ADDENDUM NO. 2

MAKUU OFFSITE WATER SYSTEM PHASE 2 PRODUCTION WELL, RESERVOIR AND SUPPORTING FACILITIES

HALONA, PUNA, ISLAND OF HAWAII, HAWAII

IFB NO.: IFB-13-HHL-002

RESERVOIR GENERAL NOTES

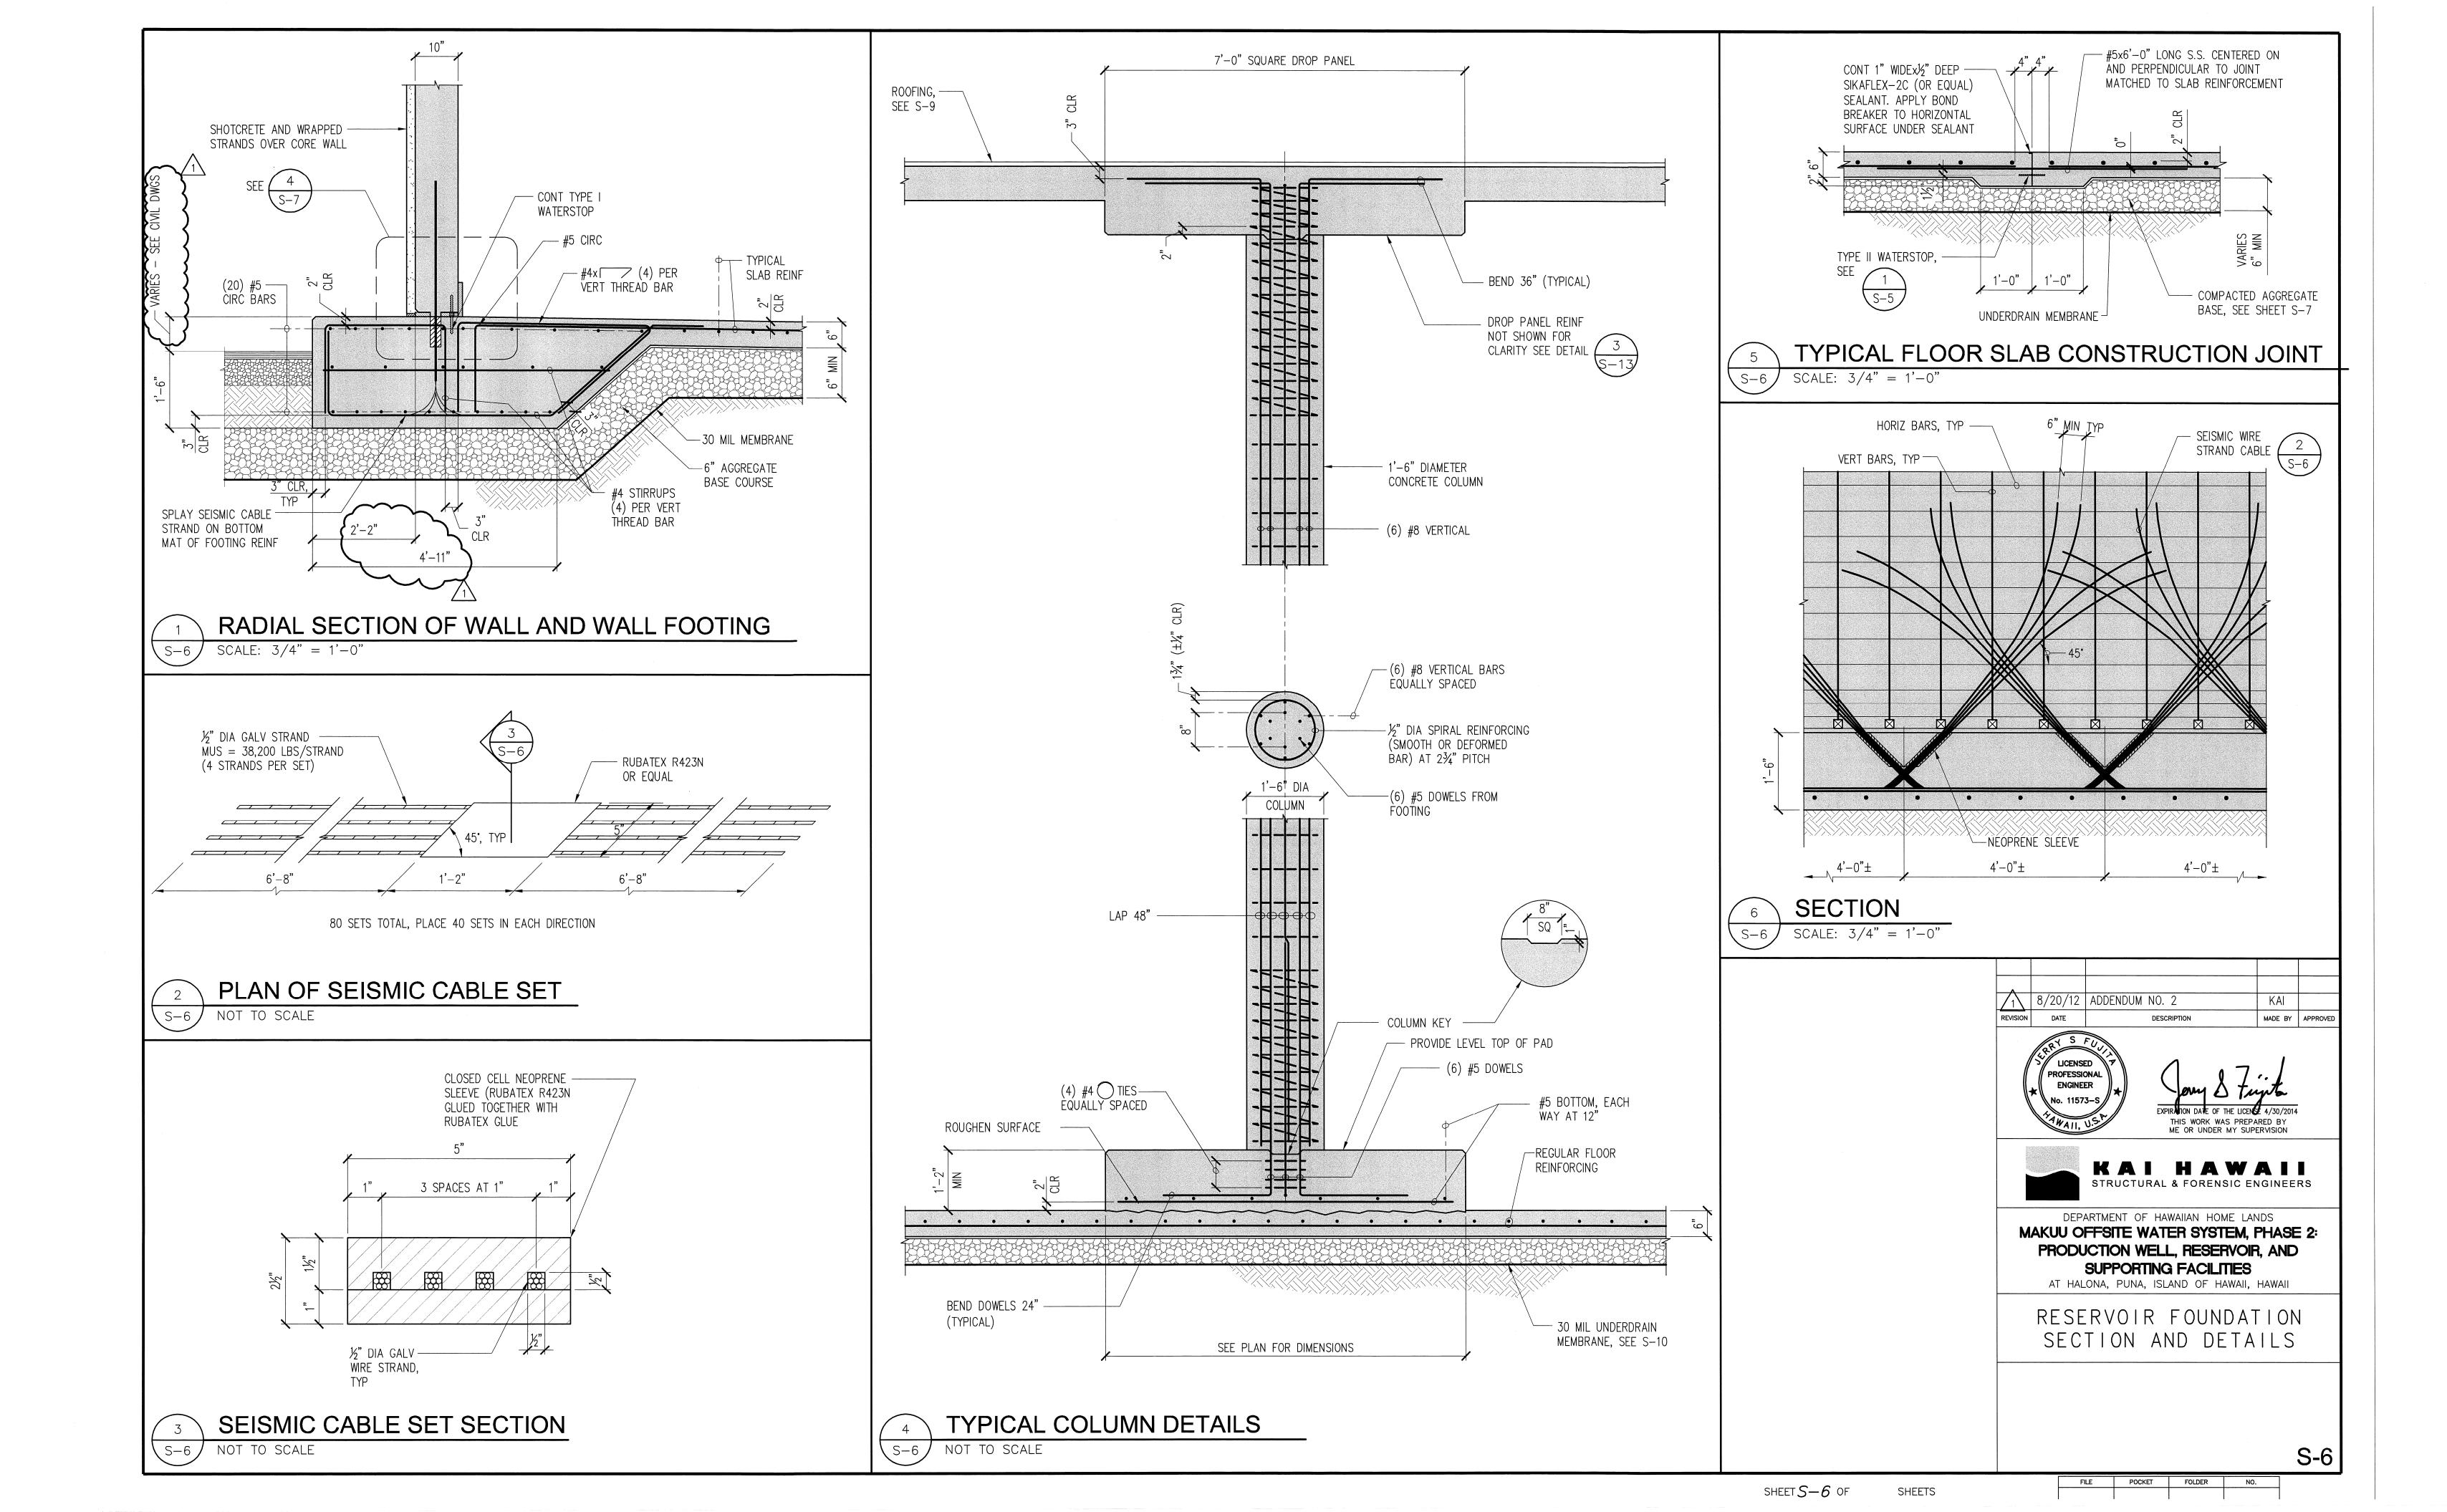
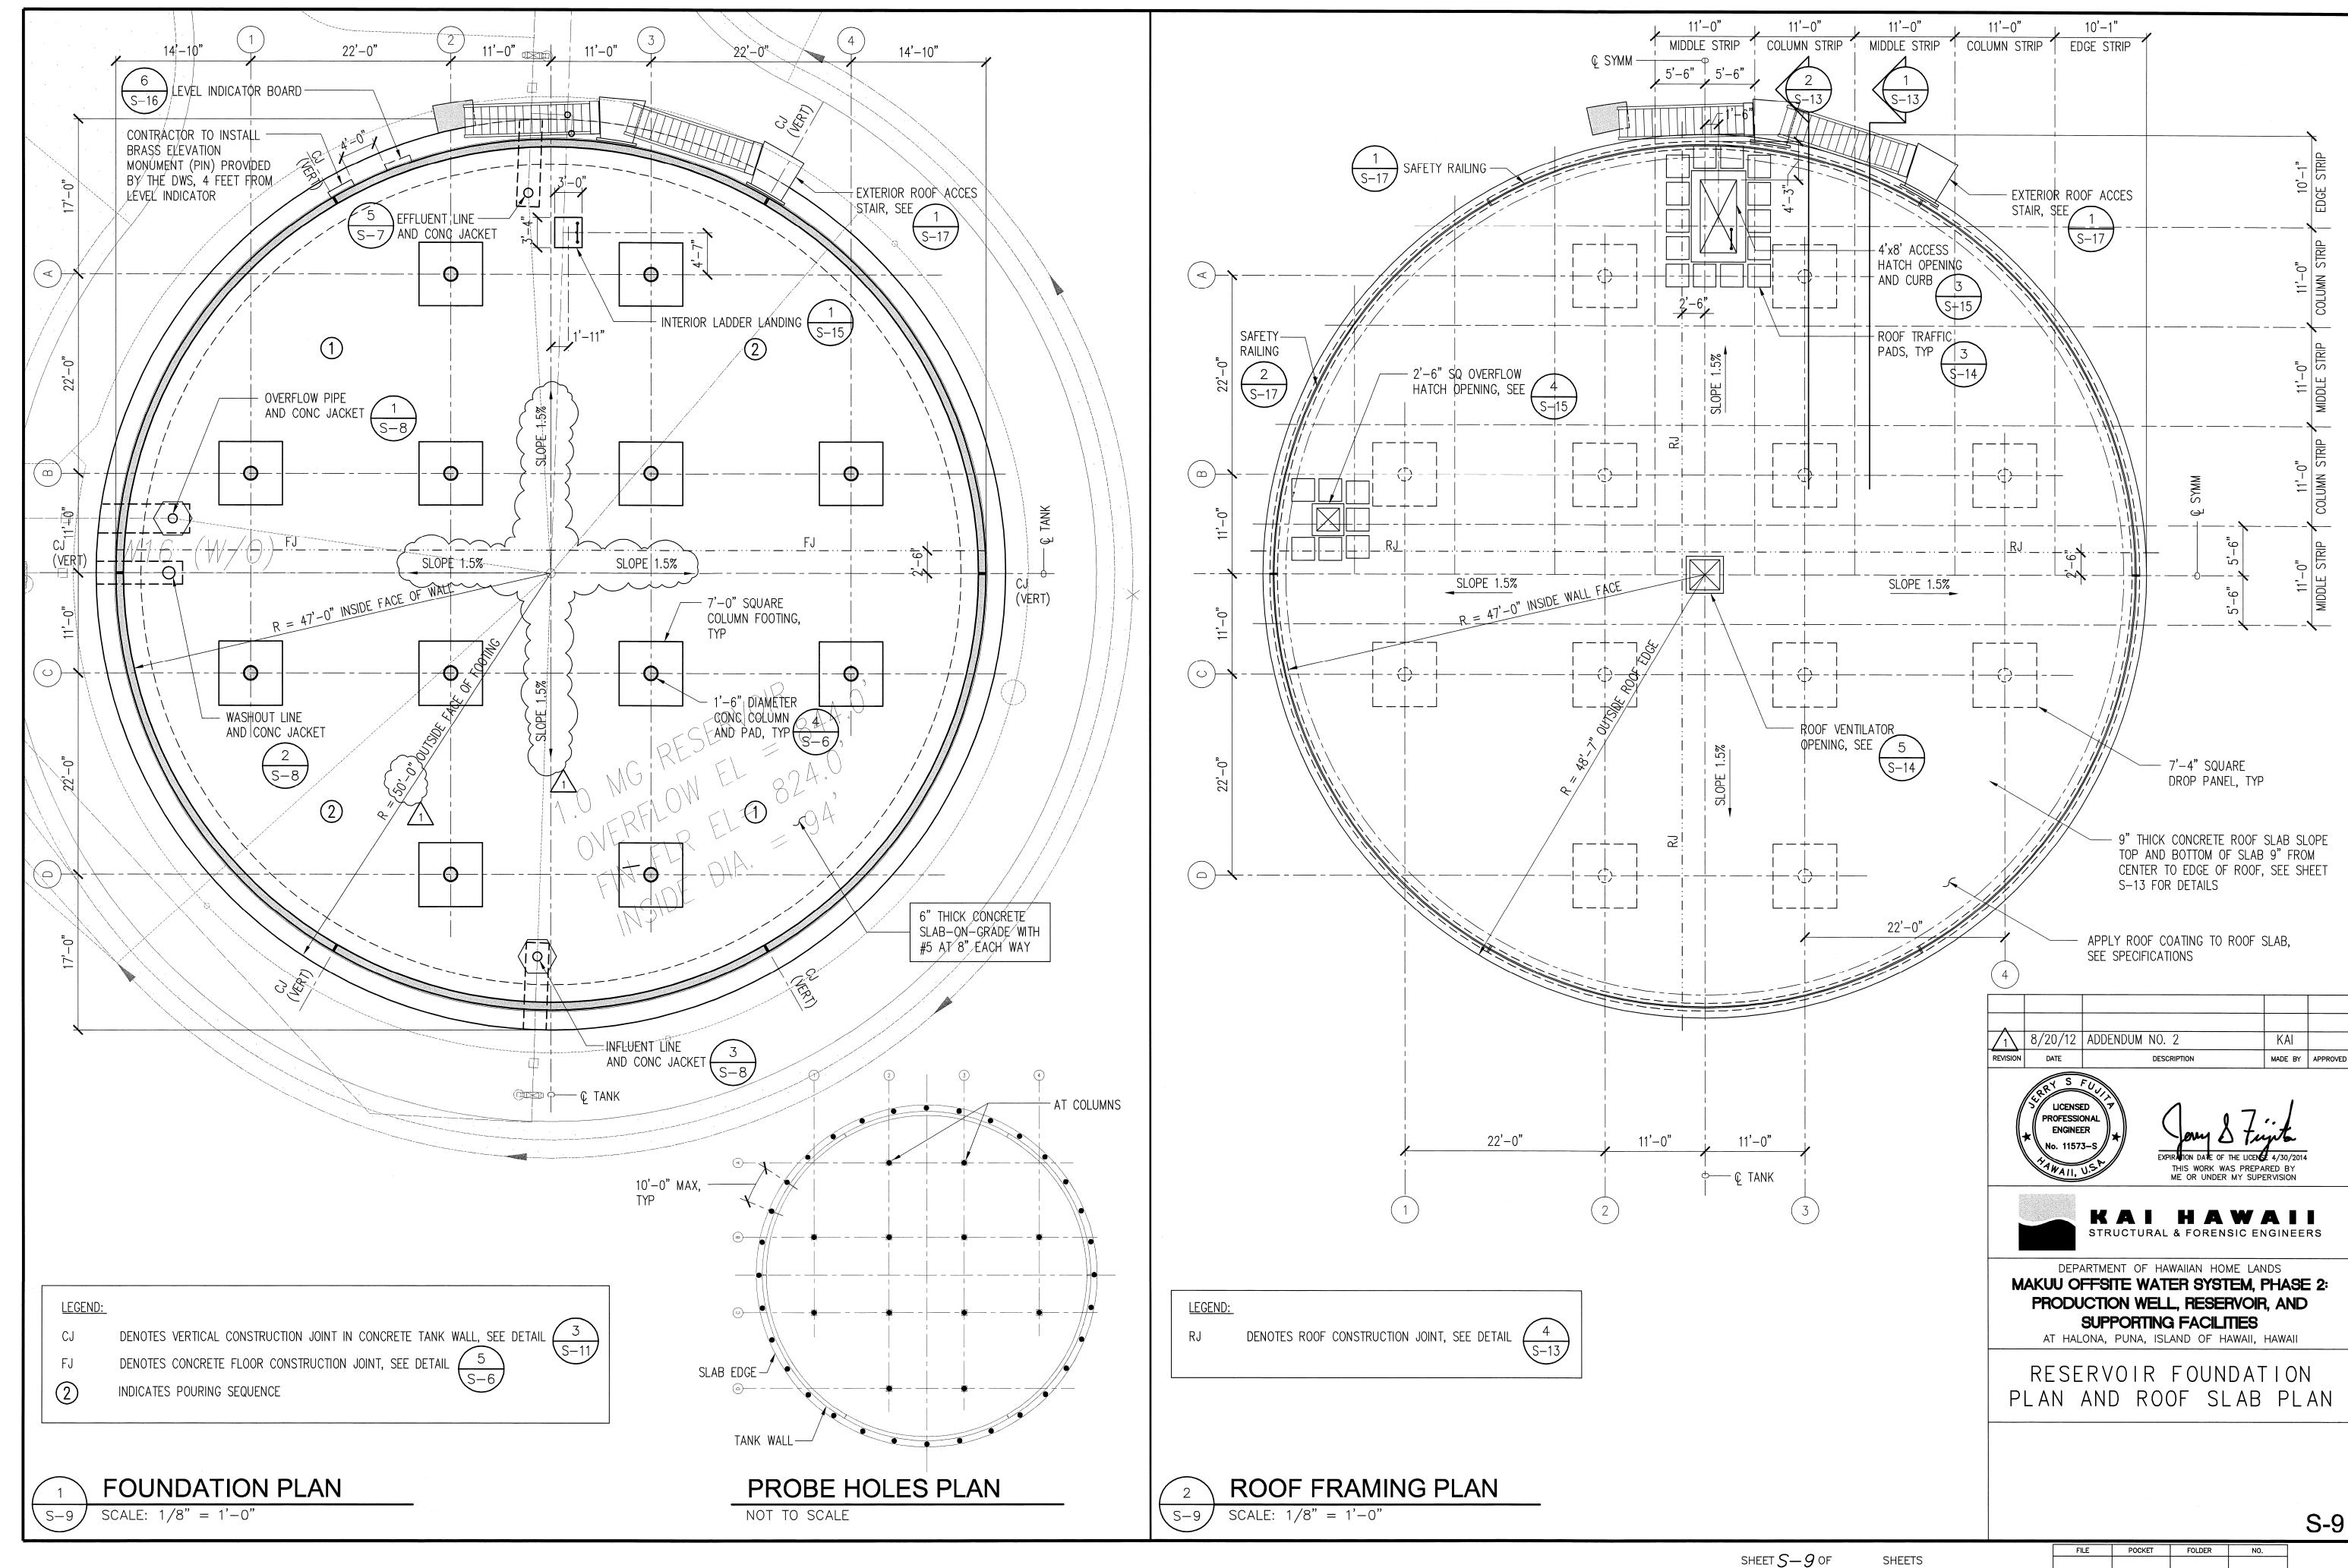
Section 303.07.F.2.n states the Importance Factor shall be 1.5 while Sheet S-4 of the drawings states the Importance Factor is 1.25. ACI 350 and AWWA D110 use 1.25 for essential facilities while IBC 2006 uses 1.5 for essential facilities. It is our understanding that Hawaii has recently adopted IBC 2006. Please have the Engineer review and determine if the project should also include IBC 2006 as part of Section 303.07.F.1 and the General Notes on Sheet S-4 of the plans and if the Importance Factor for the project should include both 1.25 and 1.5.
